Attachment E

DPS-ROW CONDITIONS OF APPROVAL

820220220 4910/4920 Strathmore

Re: 4910 / 4920 Strathmore
Site Plan No. 820220220 and Preliminary Plan No. 120220160

FIRE ACCESS PLAN

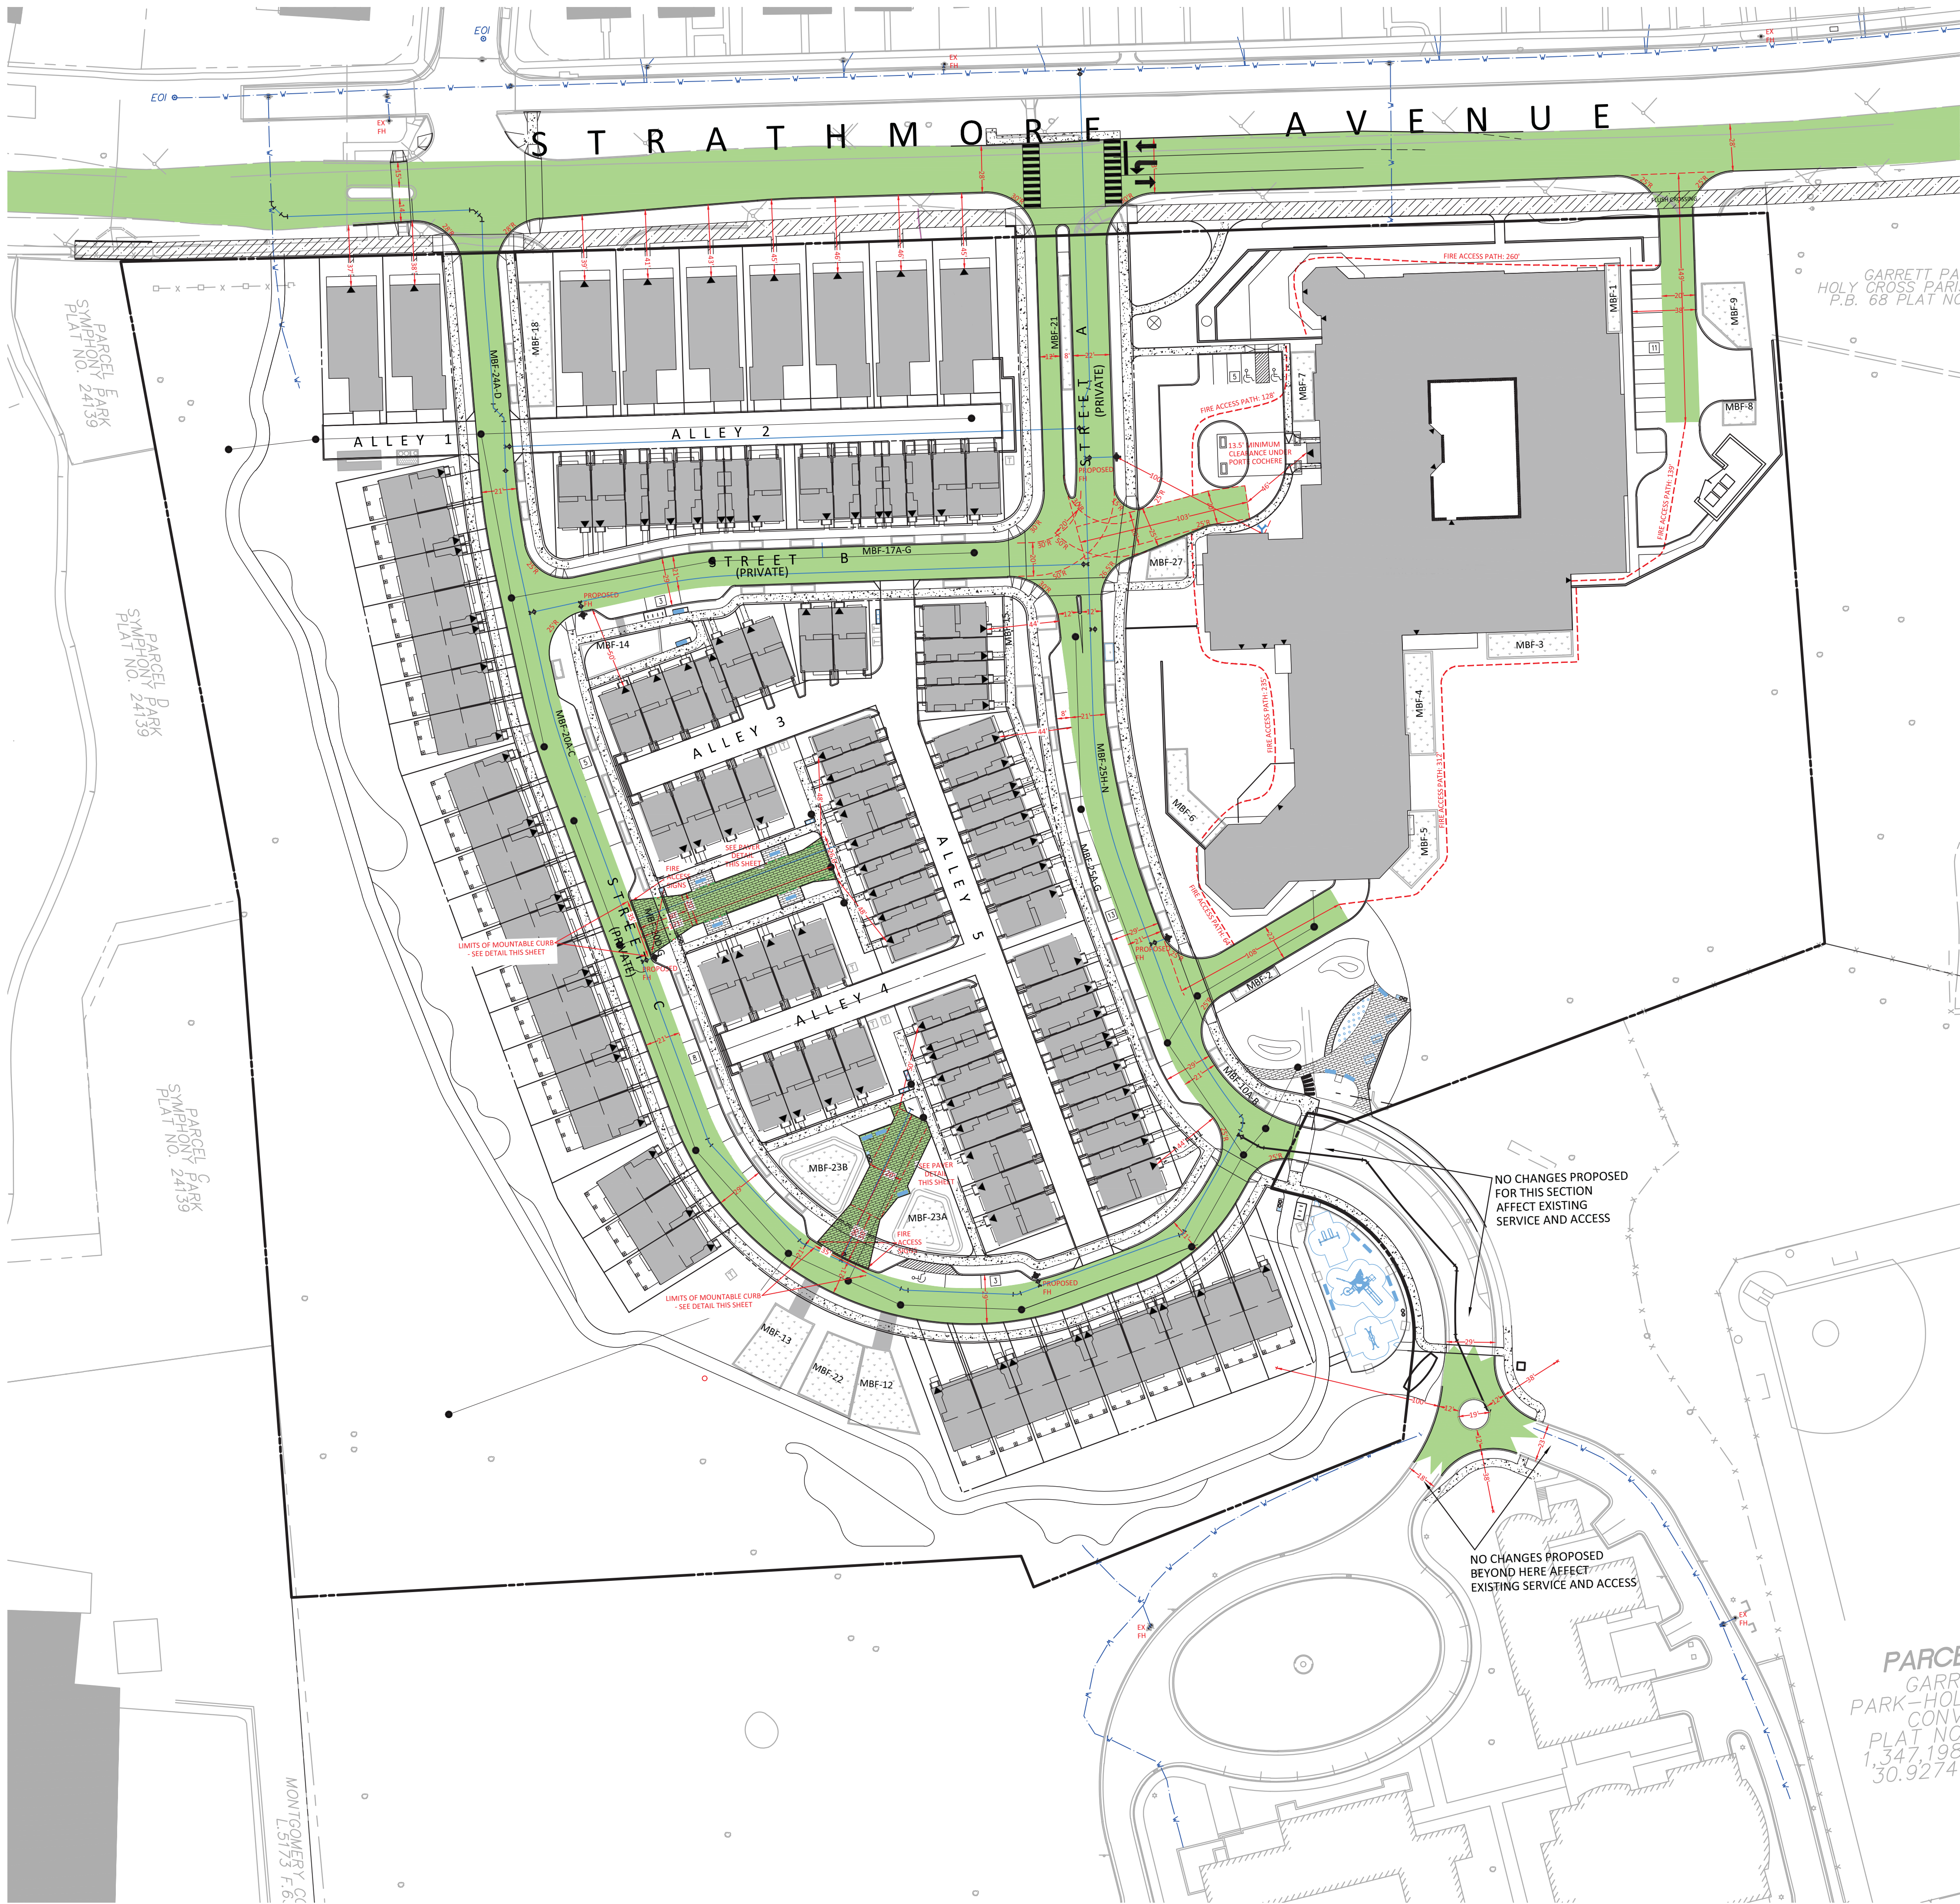
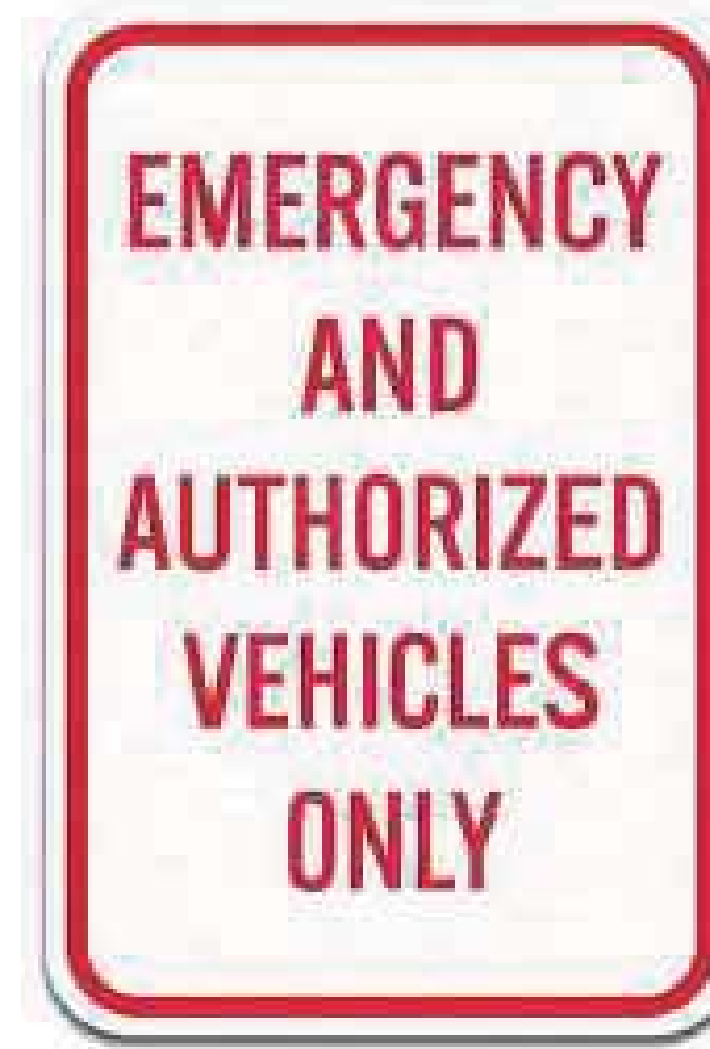
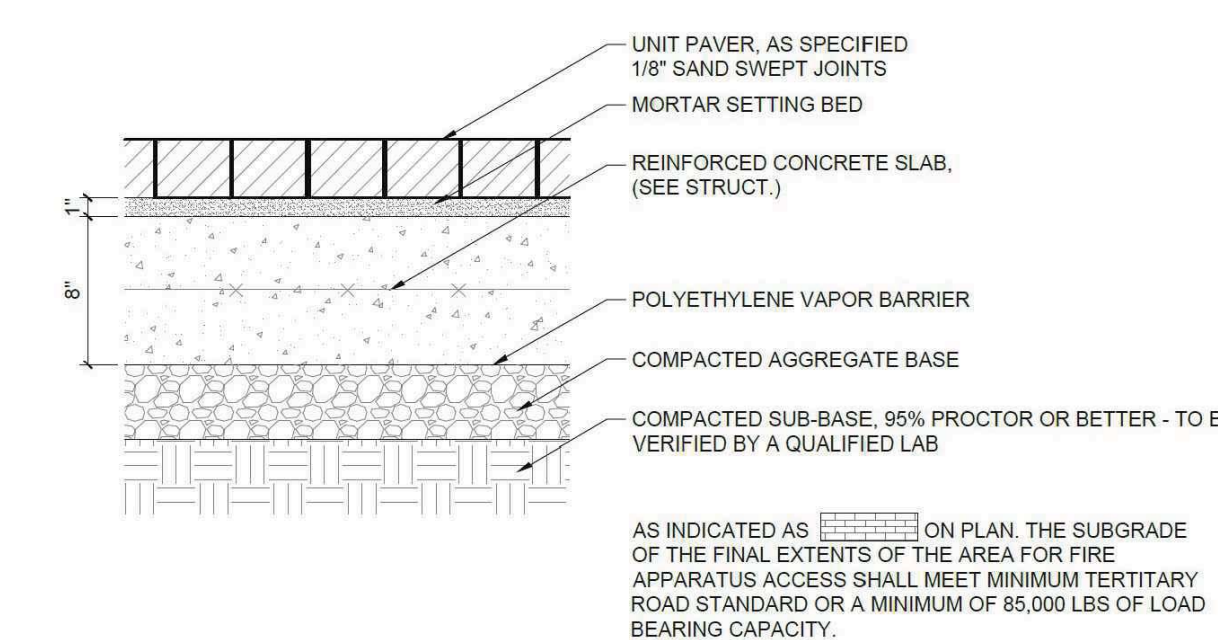
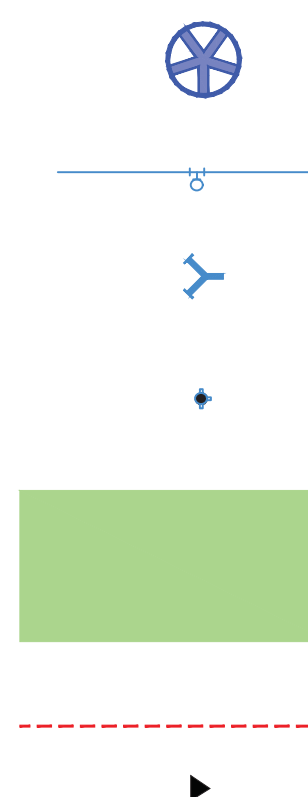
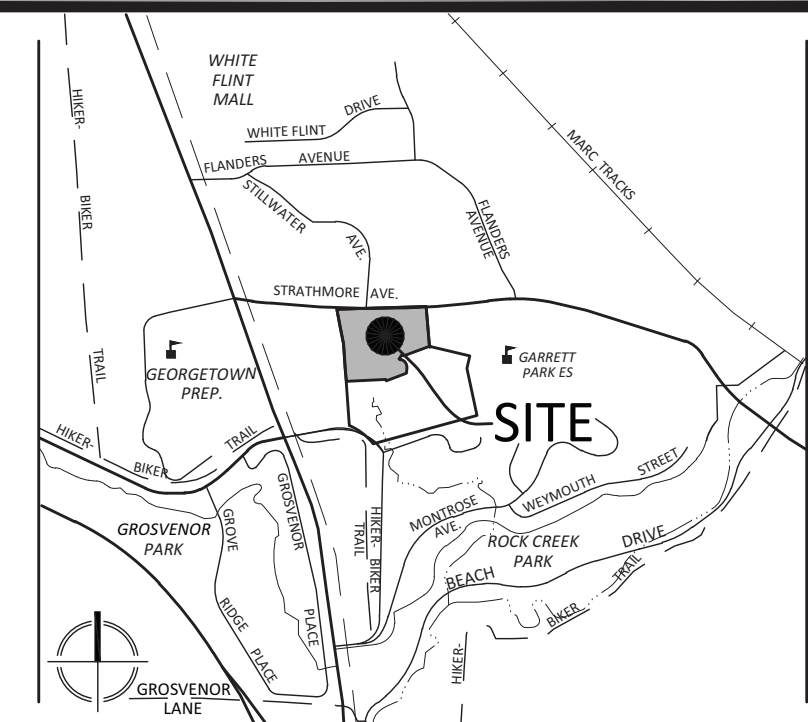
PLAN APPROVED

1. Review based only upon information contained on the plan submitted **07-Sep-22** .Review and approval does not cover unsatisfactory installation resulting from errors, omissions, or failure to clearly indicate conditions on this plan.
2. Correction of unsatisfactory installation will be required upon inspection and service of notice of violation to a party responsible for the property.
